January 18, 2019
Subject: Recall R89910
TO: All U.S. and Canadian Volvo Retailers

**Recall R89910: Tailgate Lift Arms (Drive Units)
Model Year 2018 – 2019 XC60**

| Title | Inspection and replacement of "drive units", tailgate lift arms | Page: | 1 (5) |

Condition 1

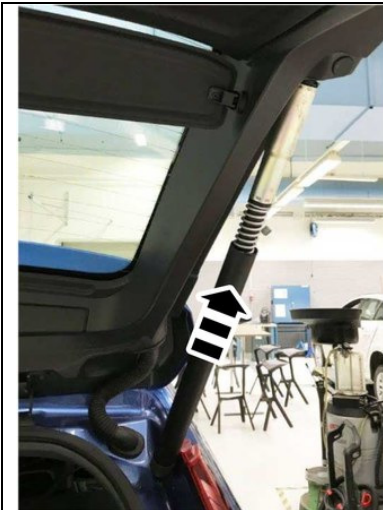
If motor, power operated tailgate looks according to image, both dampers are to be replaced according to Vida:

-Condition 1, replace the lifting arms according to VIDA VCC-370949-5.

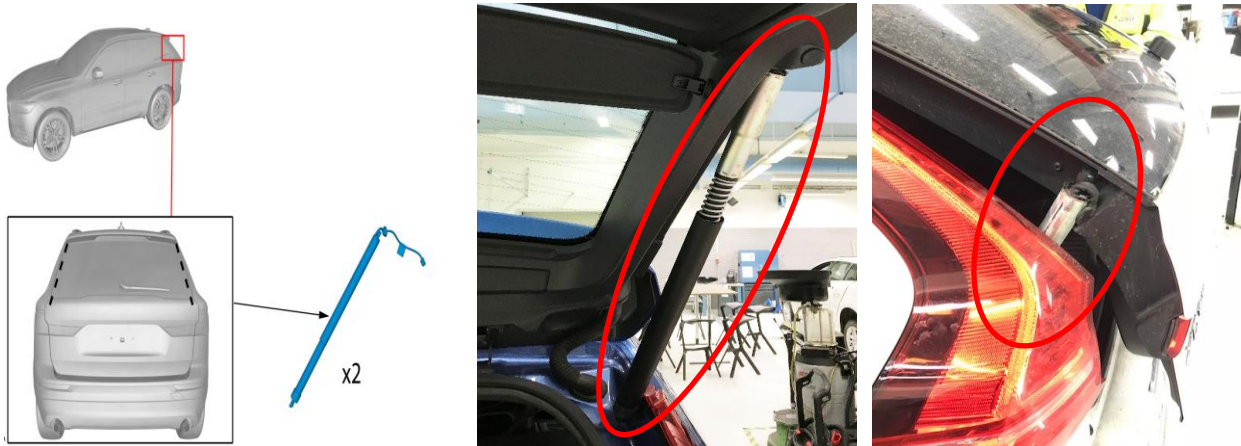
Volvo Cars investigations have identified that the tailgate lifting arms under certain conditions and cold temperatures may freeze. If this would occur, it may lead to noise or loss of function when operating the tailgate in freezing conditions with risk of separation of the tailgate lifting arms.

In certain cases, this may result in complete separation of tailgate lifting arms with spring detaching and projecting in a rearward direction with significant force resulting in risk for personal injury.

The corrective action is replacement of the tailgate lifting arms with an improved design part **at no cost to you**.

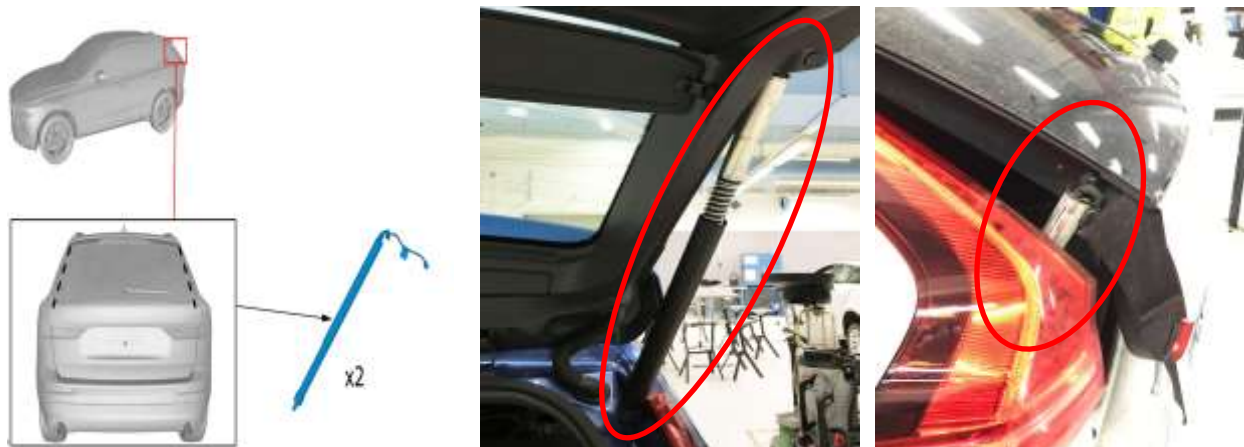
Las investigaciones de Volvo Car identificaron que los brazos de elevación de la compuerta trasera, en ciertas condiciones y con temperaturas frías, pueden congelarse. Si esto ocurriera, podría causar ruidos o pérdida de la función al operar la compuerta trasera en condiciones de frío intenso, con riesgo de que se separen los brazos de elevación de la compuerta trasera.

En ciertos casos, esto puede provocar la separación total de los brazos de elevación de la compuerta trasera, con desprendimiento del resorte y proyección hacia atrás con fuerza considerable, que provoque un riesgo de lesiones personales.

La medida correctiva es el reemplazo de los brazos de elevación de la compuerta trasera, por una pieza con diseño mejorado, **sin costo para usted.**
